Preservation Department – Item 1, LPC-22-08731

**6301 12th Avenue, aka 6301-6323 12th Avenue, 1202-1216 63rd
Street, and 1201-1215 64th Street – Angel Guardian Home –
Individual Landmark
Borough of Brooklyn**

LPC-22-08731: 6301 12th Avenue, Angel Guardian Home - Individual Landmark

PUBLIC MEETING SCOPE 09/20/2022

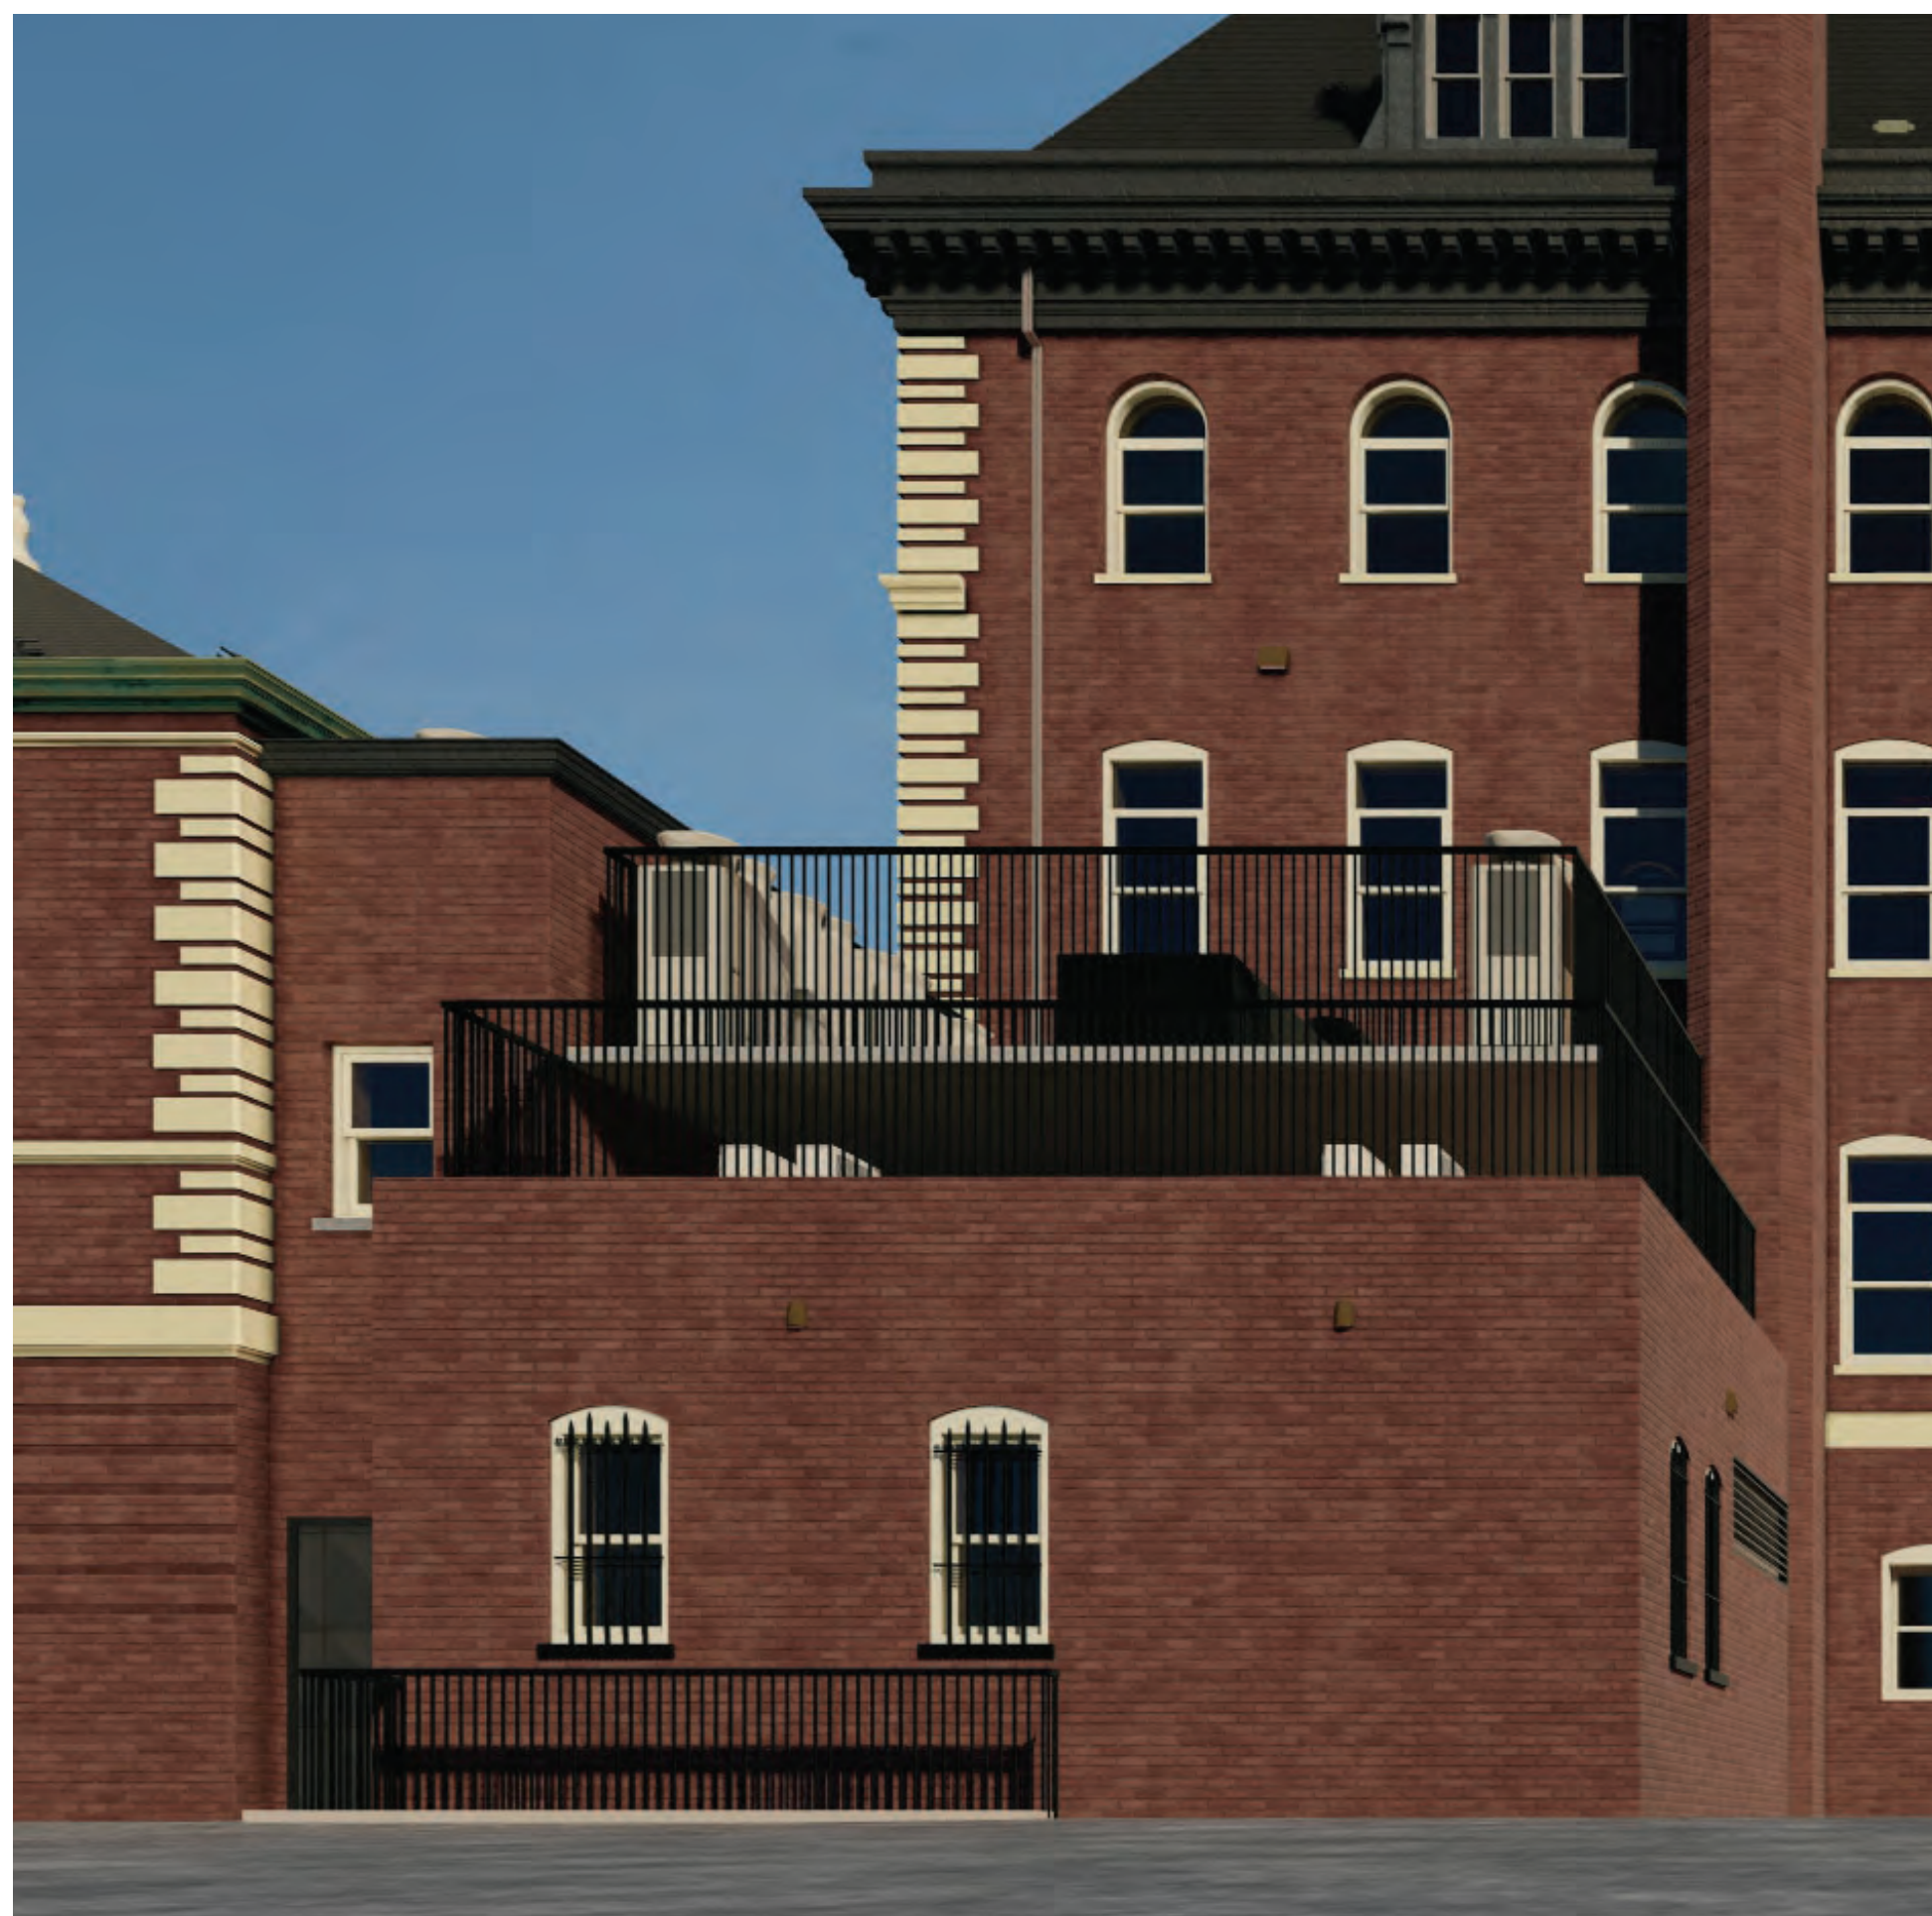
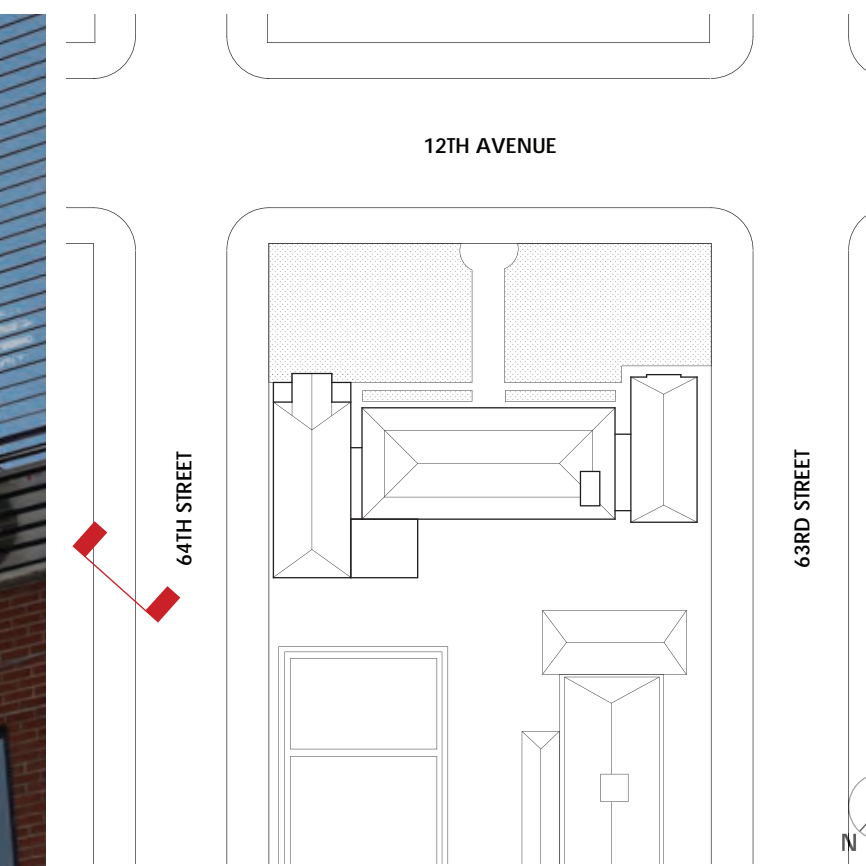
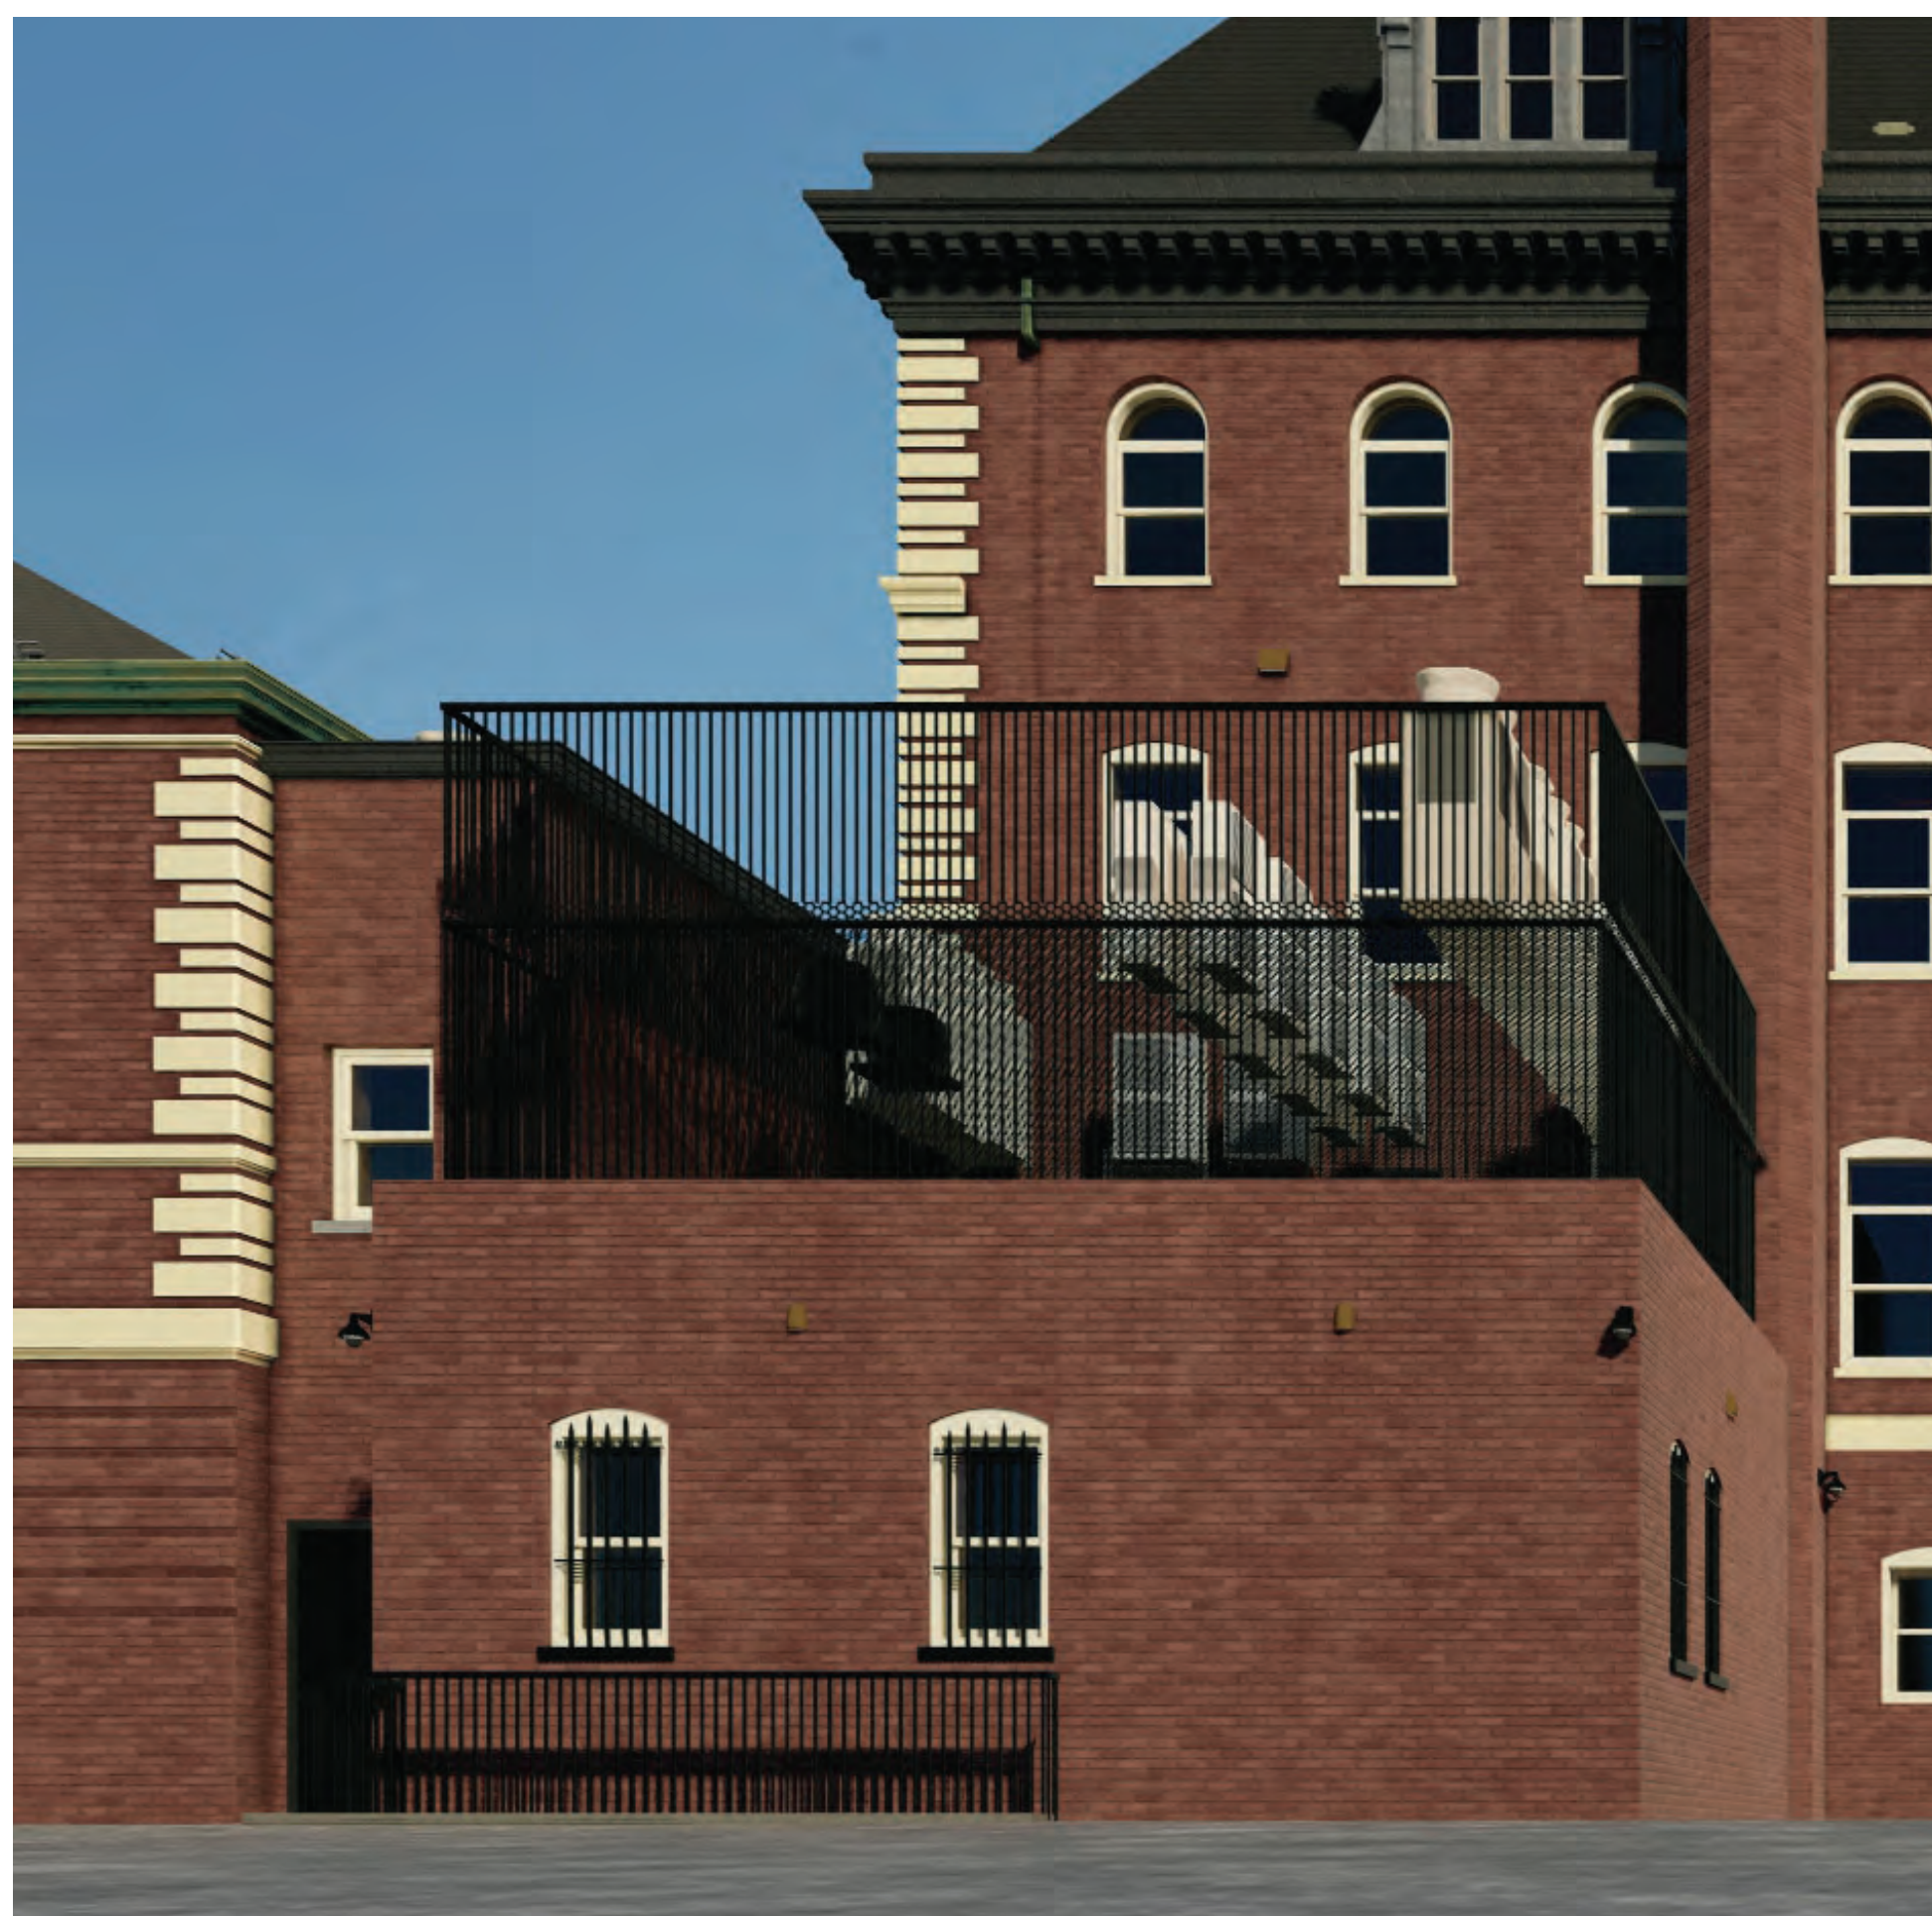
- CHANGES:
- EXPAND DUNNAGE SPACE FOR MORE EQUIPMENT
 - RAISE HEIGHT OF FIRST LEVEL DUNNAGE
 - WIDE MECHANICAL LOUVRE REMOVED
 - ADDITIONAL REAR FACADE LIGHT FIXTURES
 - ADDED REAR FACADE SECURITY CAMERA FIXTURES
